# TOWN OF GLASTONBURY

GL-2023-12

## FIRE HOUSE IMPROVEMENTS

ADDENDUM NO. 4

DWG. NO.  
**M1**

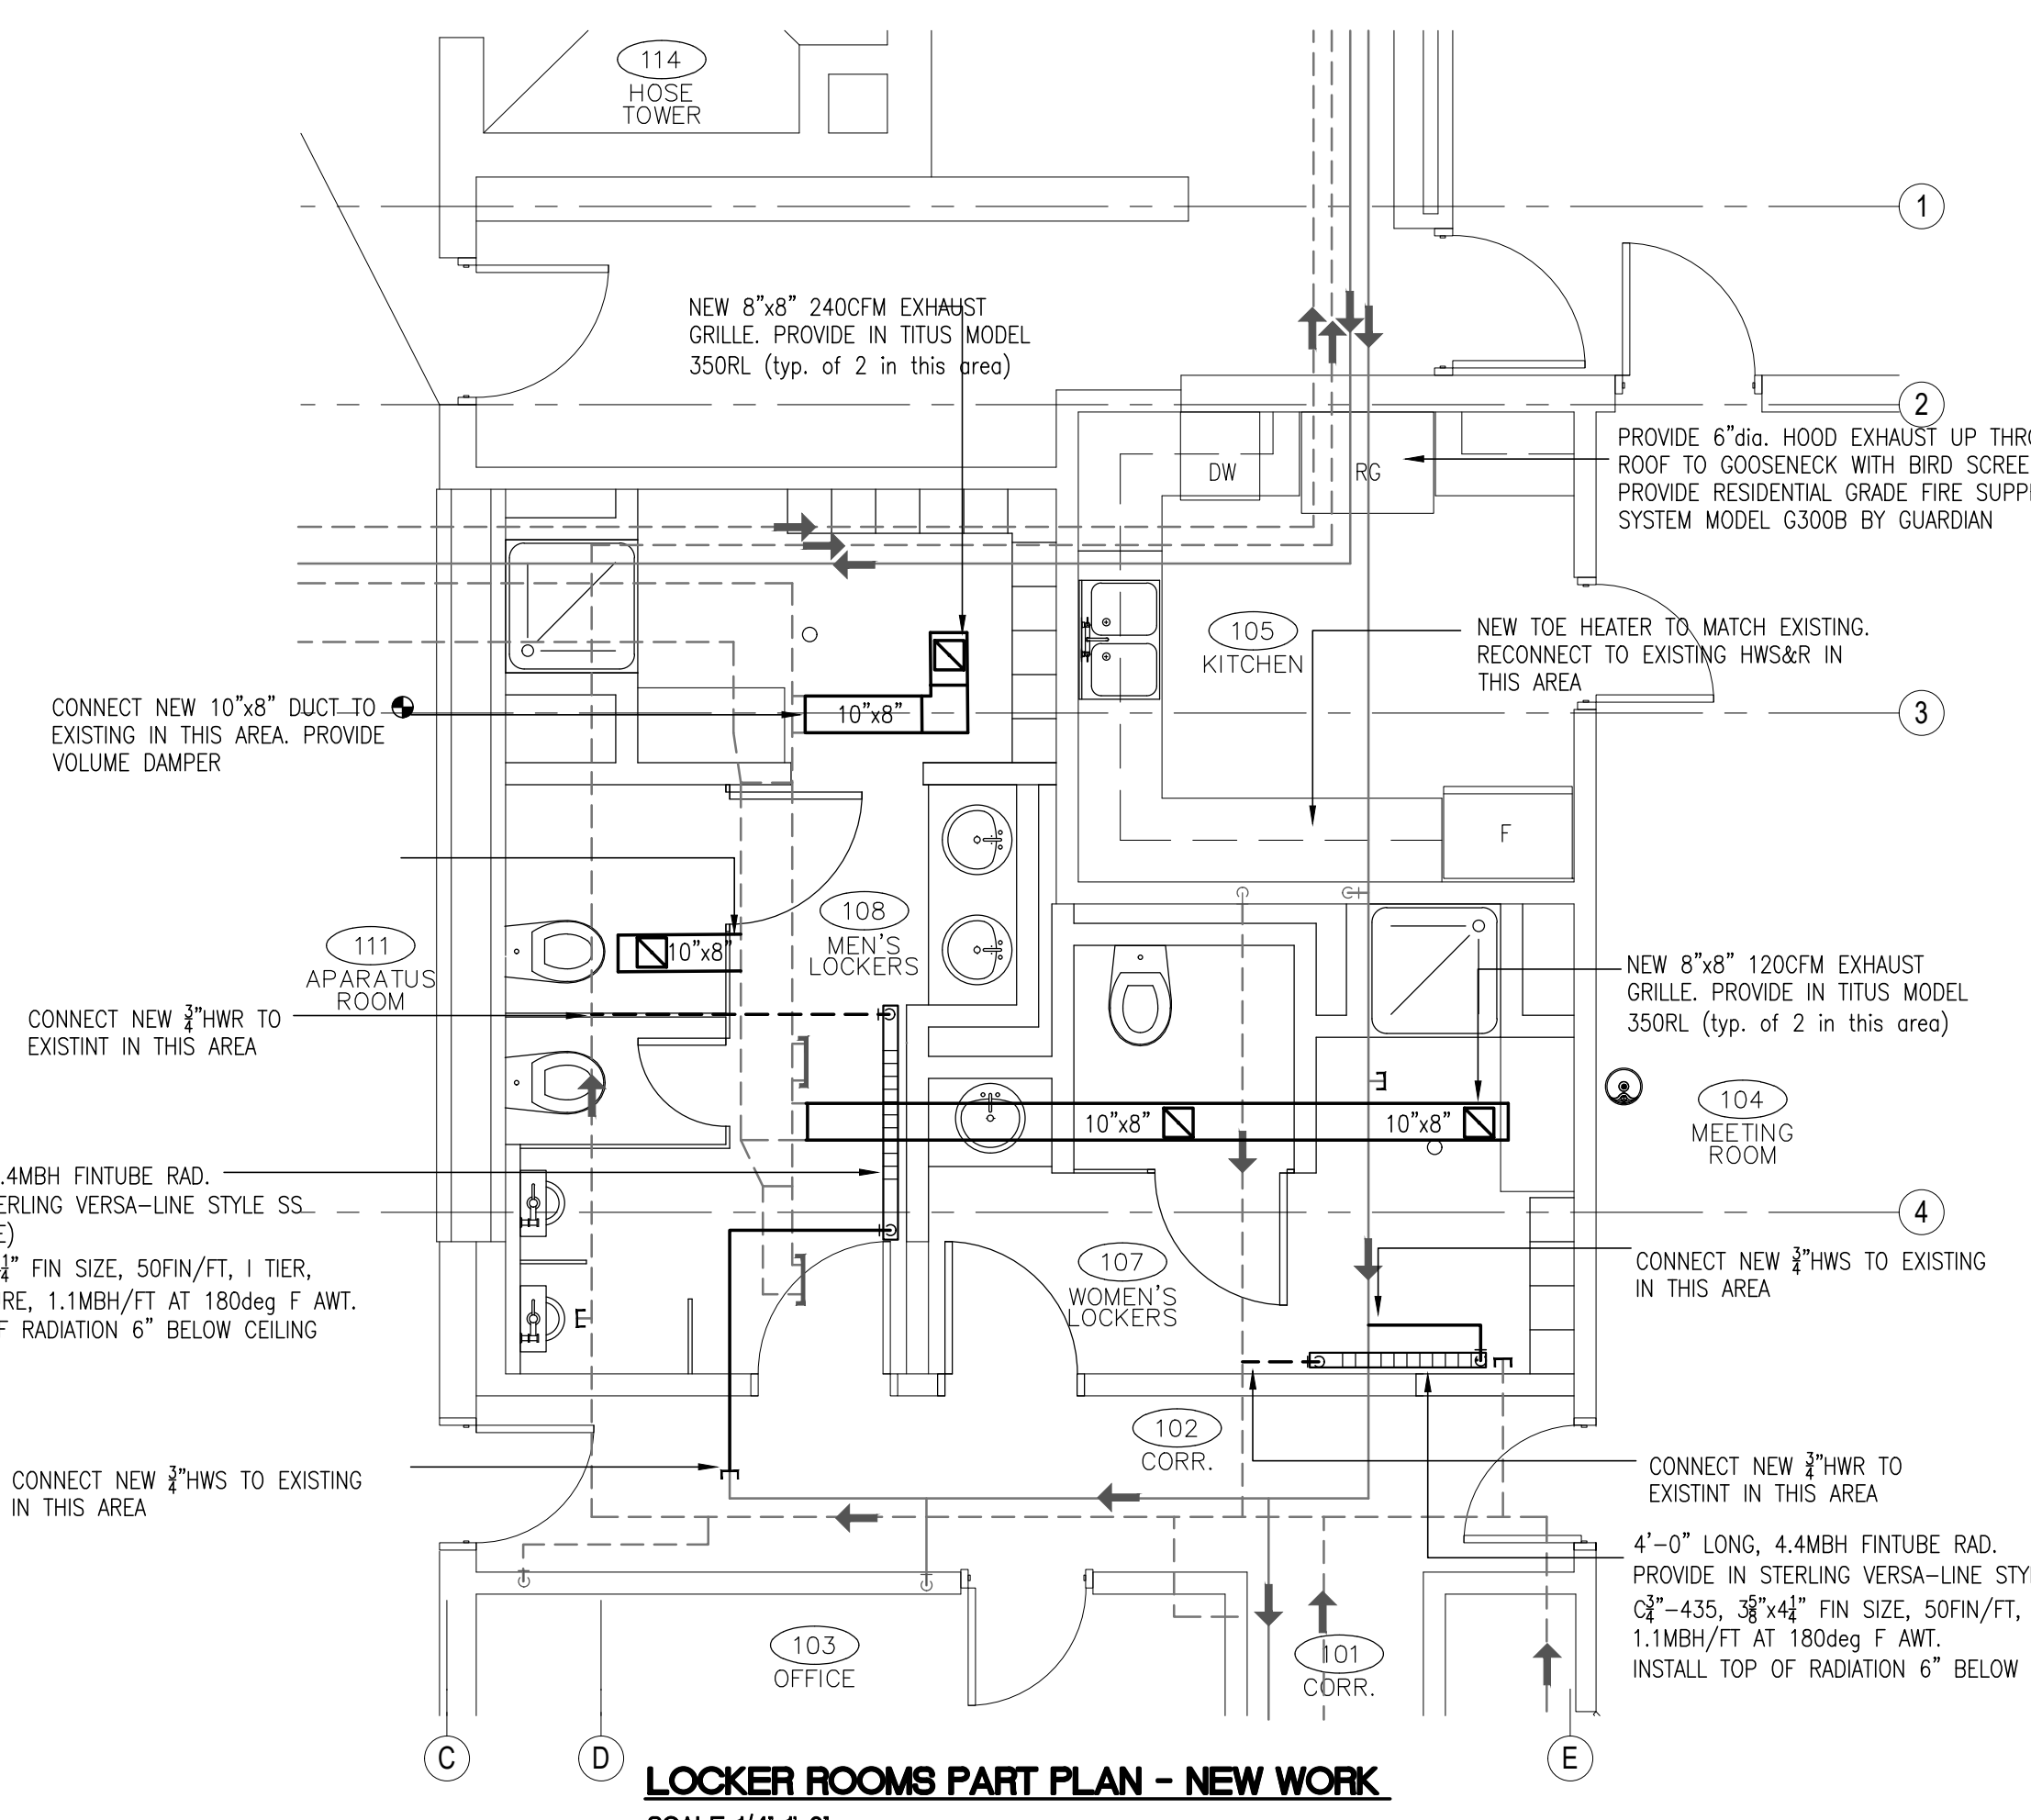
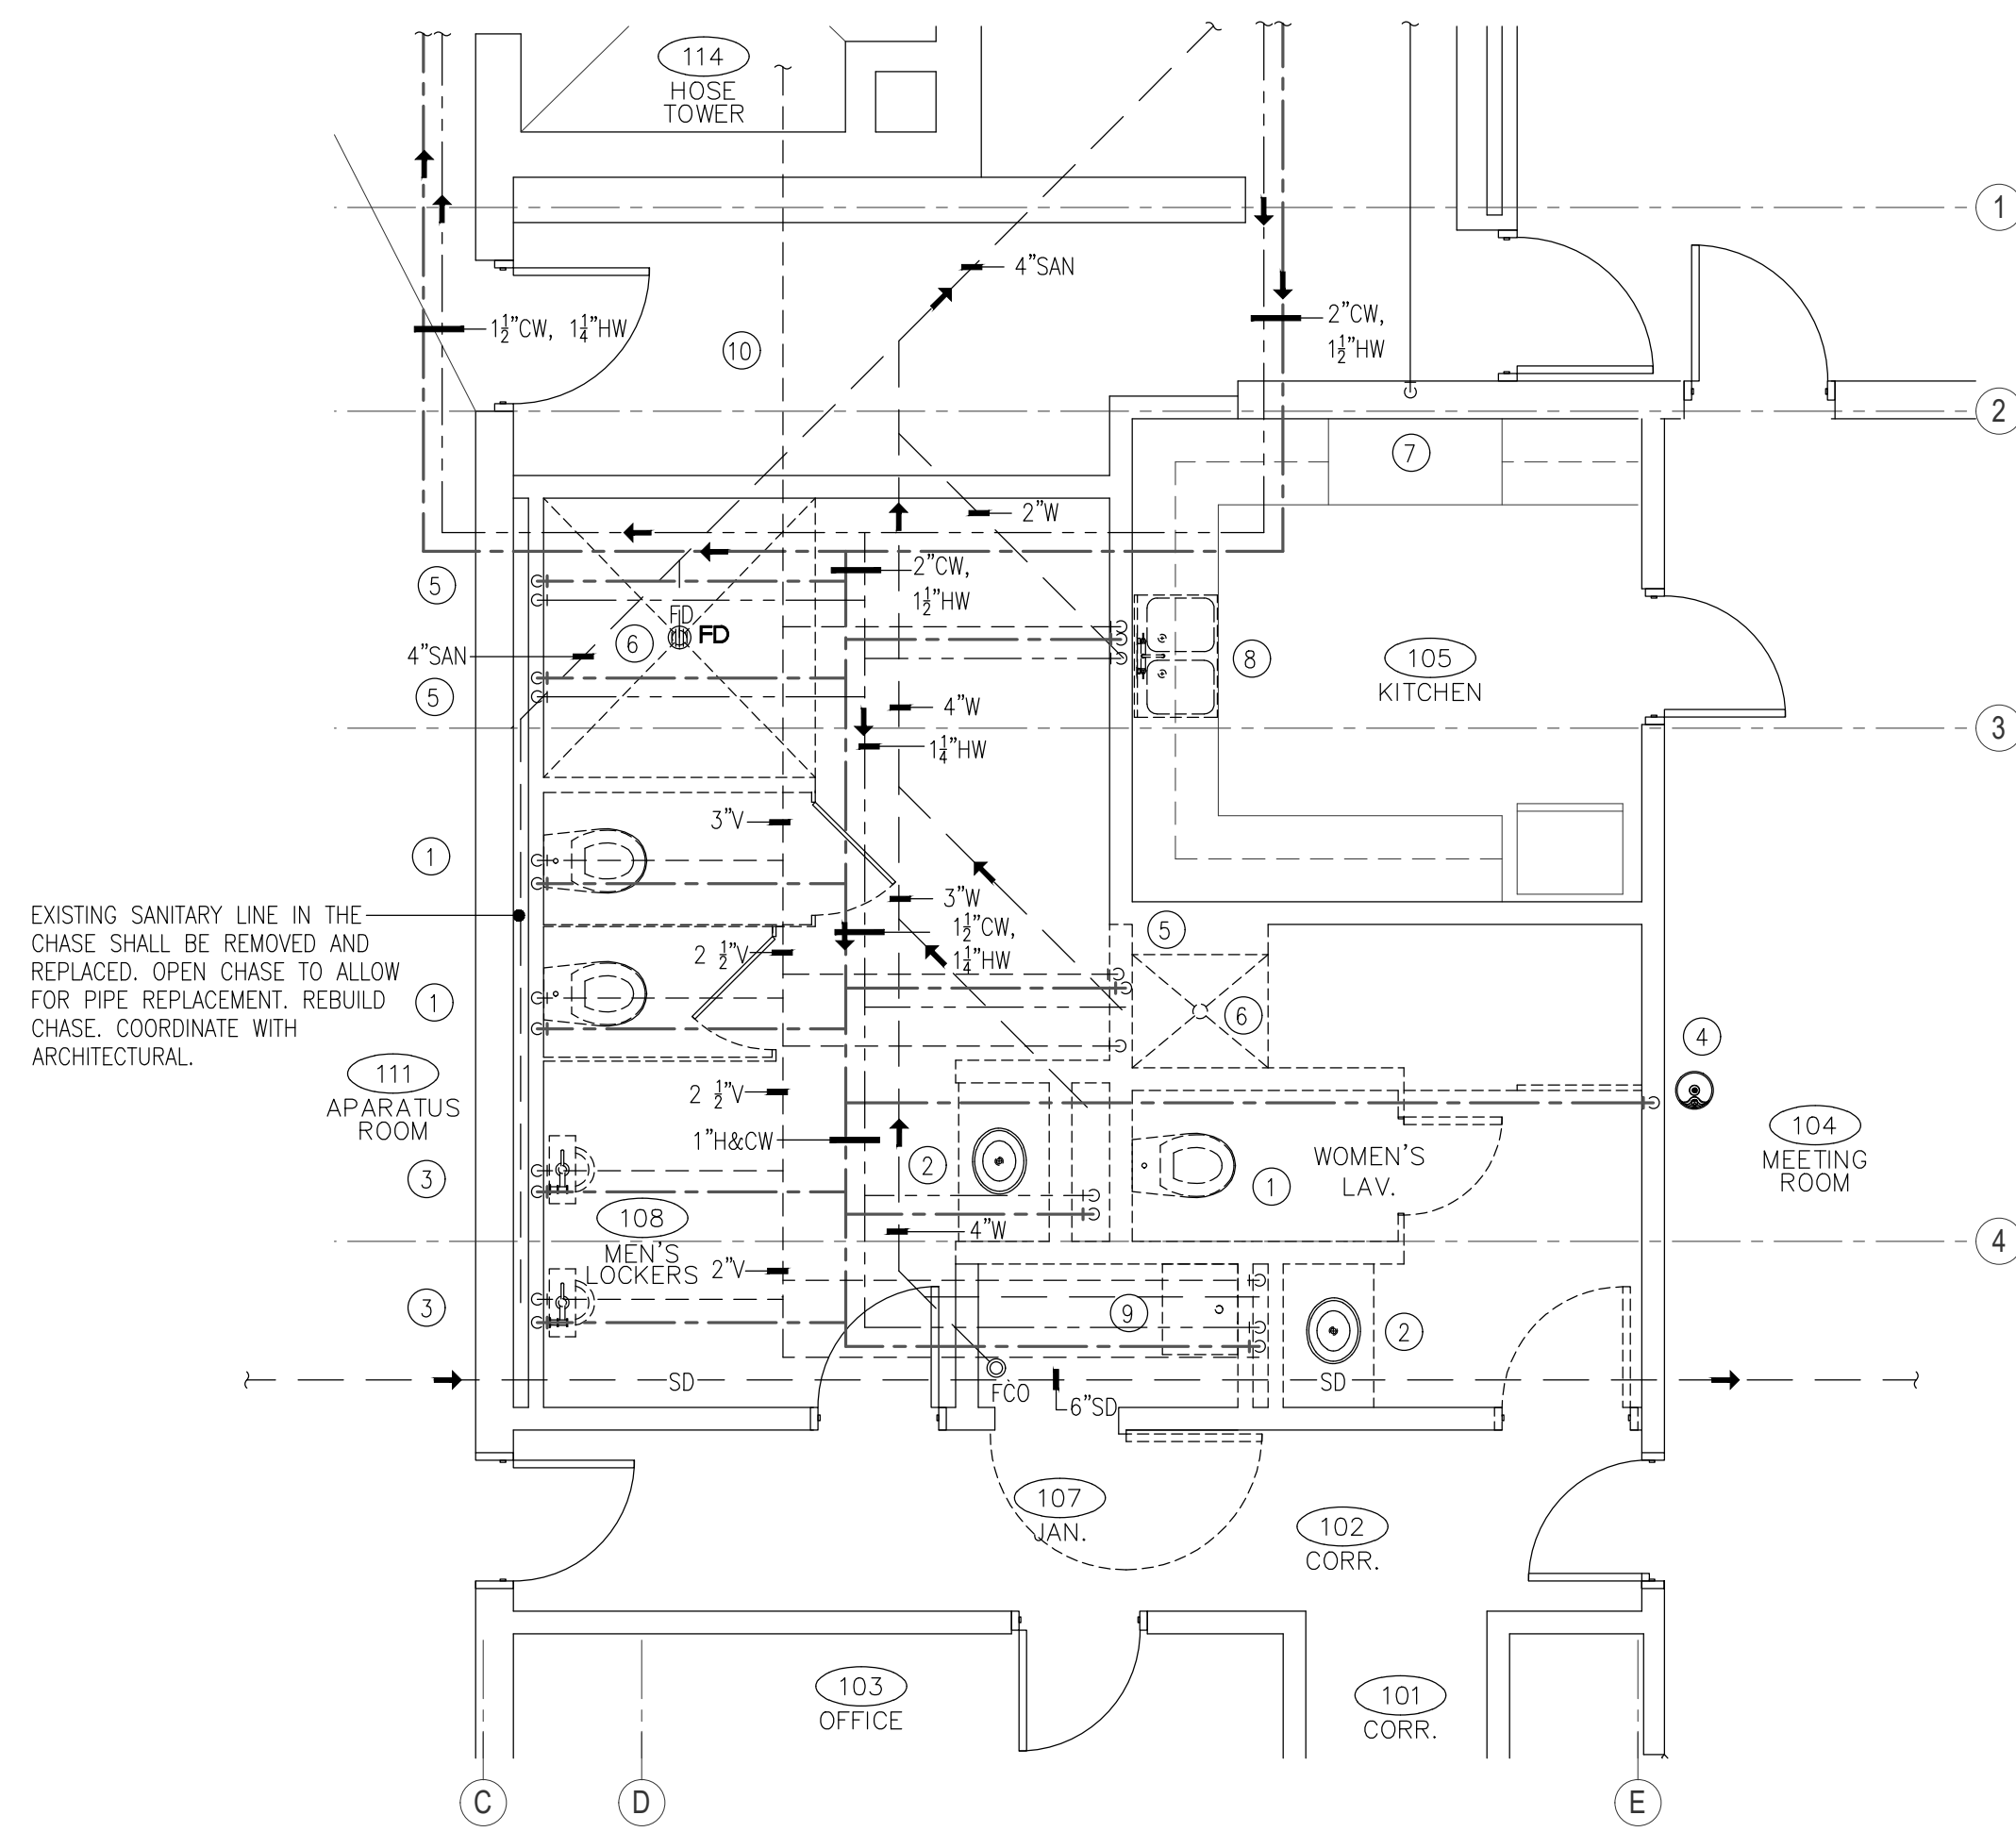
**Question 8:** *Please clearly define the extent of the HVAC work the contractor is responsible for.*

**Answer:** See Drawing M1
